FC4 - 0614

## Schematic & Parts List: PIC18F2550 50/500MHZ Frequency Counter & RF Meter

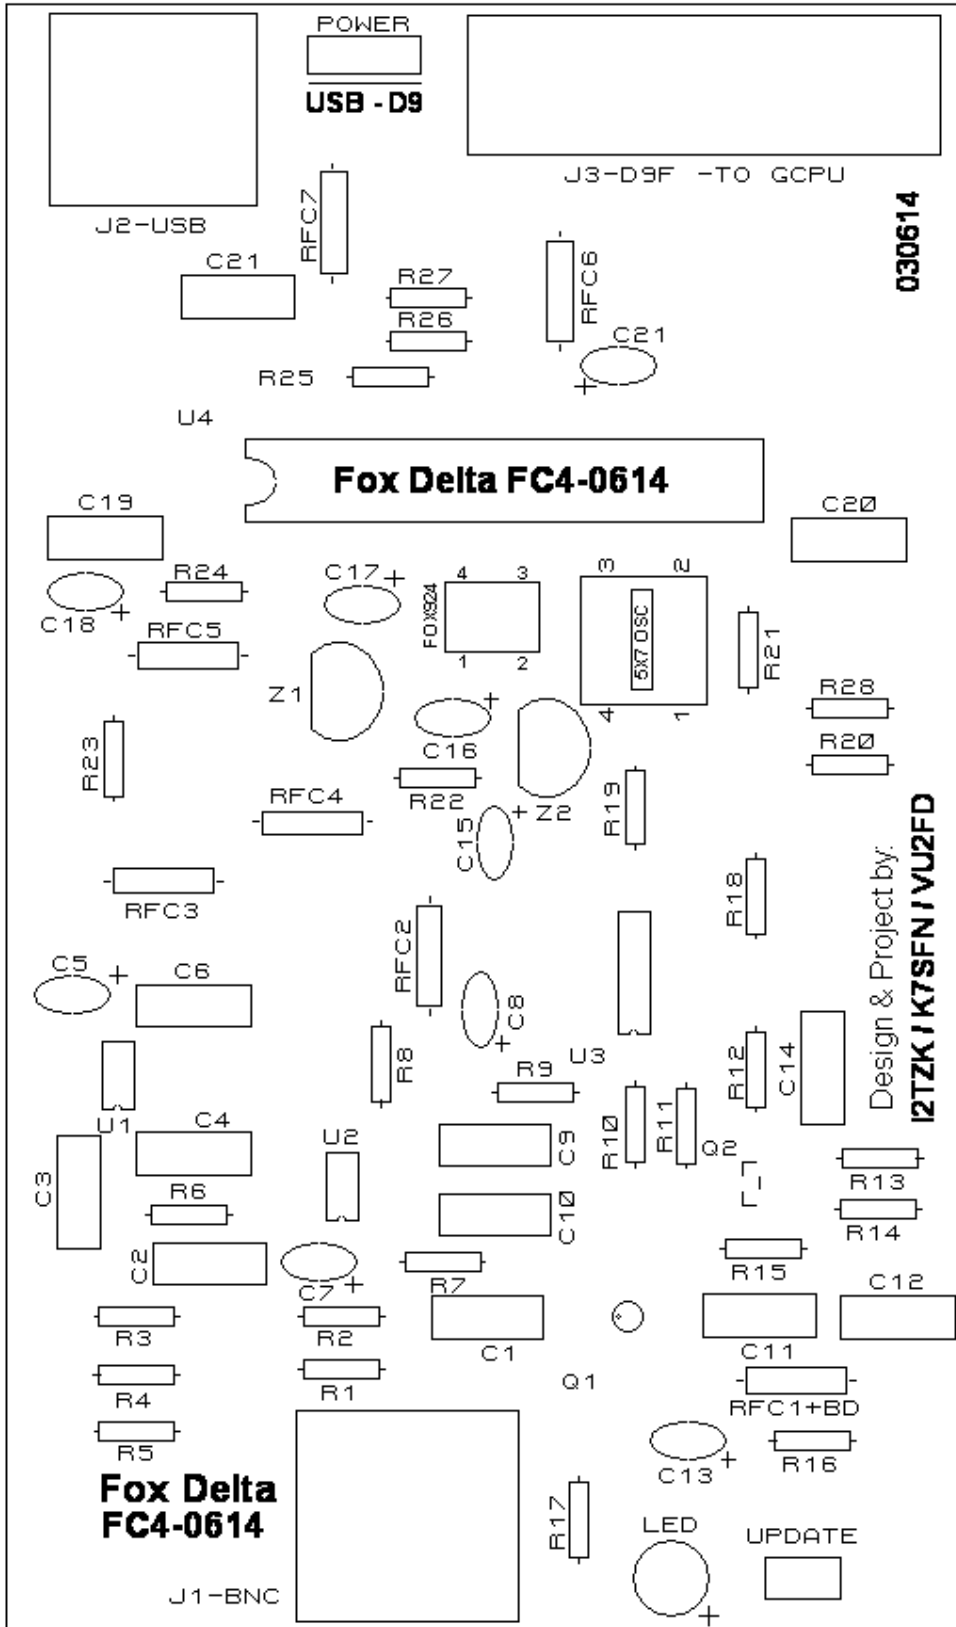
## FC4-0614 PCBs has one silk error:

**C21 are at two places:**

**C21 Rectangle is 0.1uF Poly**

**C21 oval with polarity mark is 1uF tantalum**

**Schematic Error:**

**C9 is marked in Schematic as 1n (.001) is now replaced by 0.01uf**
